ZANCOR HOMES

OLDE WINCHESTER
BROOKLIN, ONT

SITE GRADING PLAN

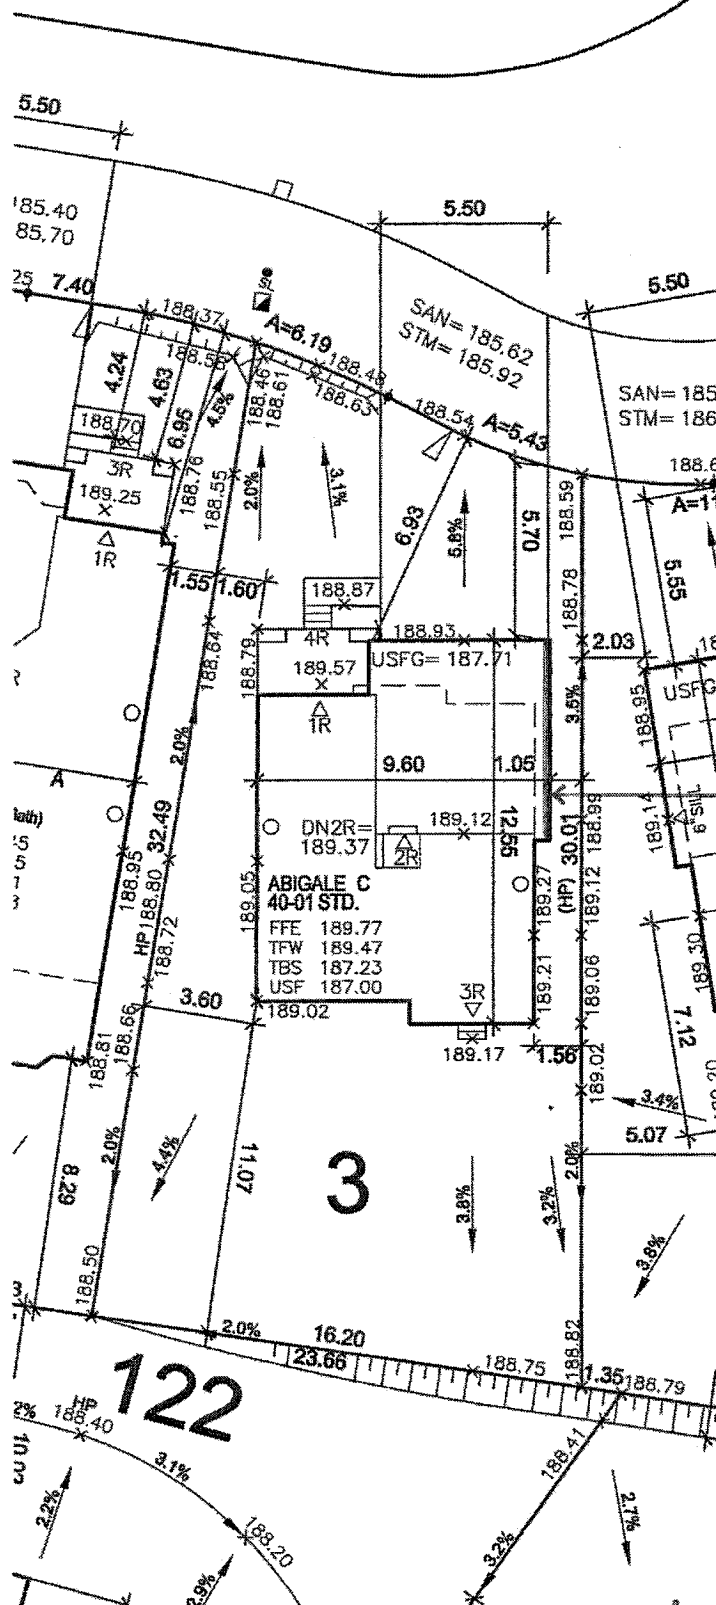
LOT GRADING PLANS APPROVED
SUBJECT TO REVISIONS NOTED

PROVIDE MINIMUM 45 MINUTE
FIRE-RESISTANCE RATING TO
EXPOSED BUILDING FACE AS
REQUIRED BY OBC 9.10.14.5
